## **REQUEST FOR BID**

**BID NUMBER: CC-10 Renovation to Stairwell  
& Install New HVAC Unit at Old Jail**

### **Addendum #3**

This addendum is dated November 19, 2013  
Answers to questions

1 PARTIAL SOUTH ELEVATION  
 SCALE: 1/4" = 1'-0"

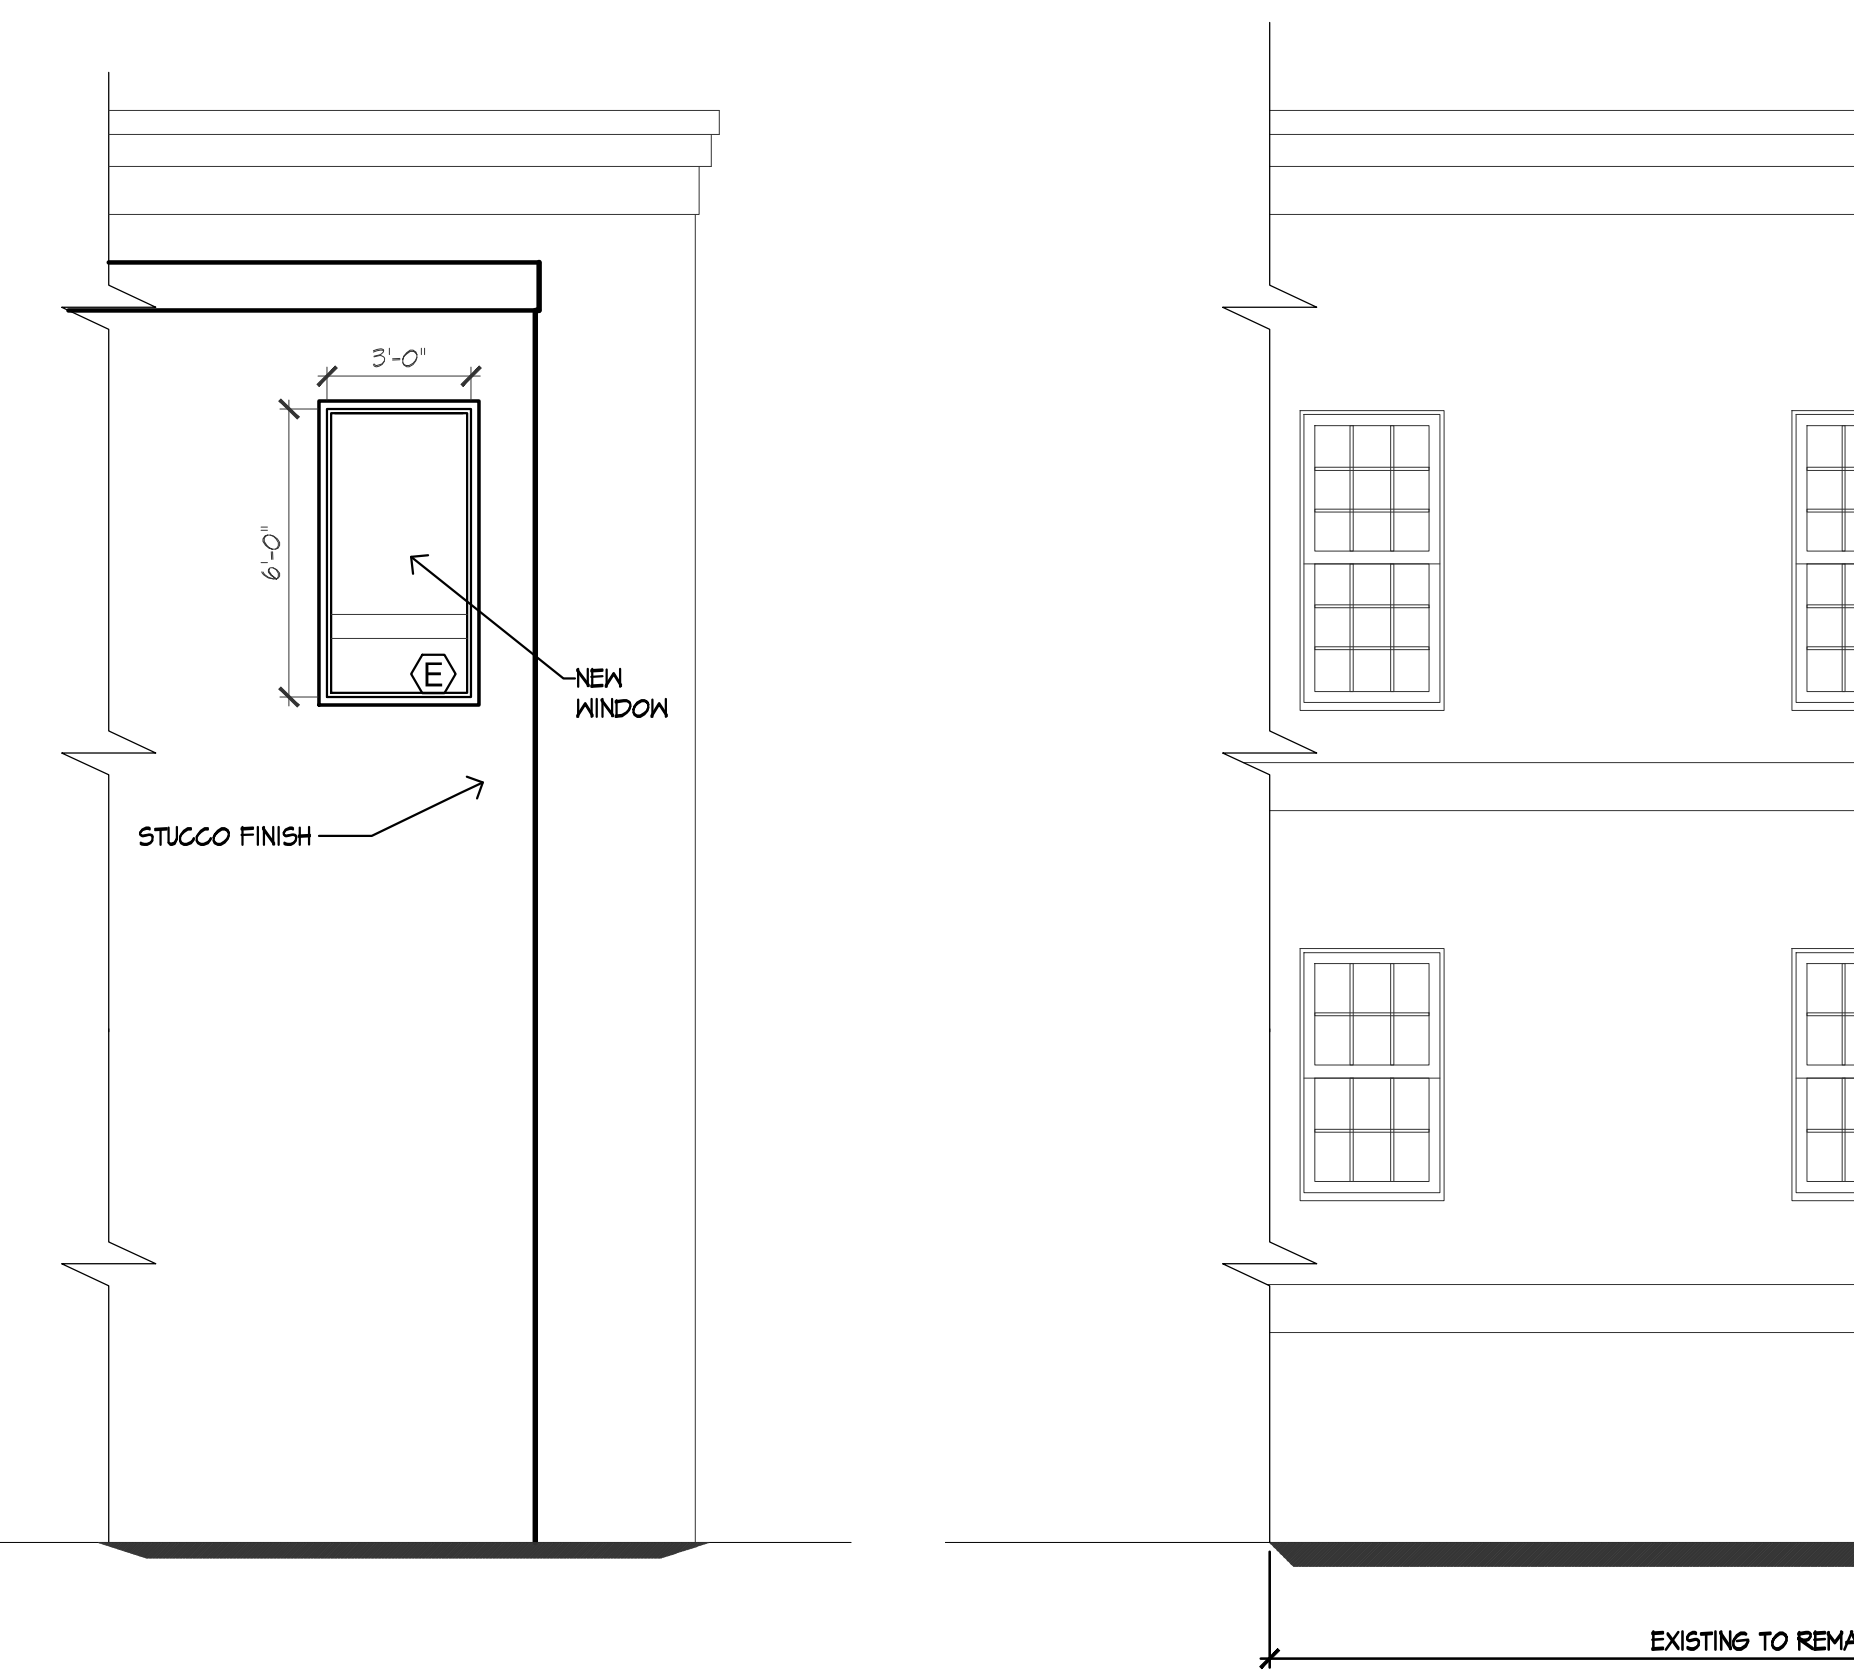
6. Please verify window size. The top windows on South Elevation (sheet A200) scales to be 6'-0" high and the bottom windows and all the windows on the North Elevation (sheet A200) are 5'-0" high. Also, Side Elevation window scales to be 3'-0" wide x 6'-0" tall, however this is not listed on the schedule. **Answer:** Please see revised schedule.
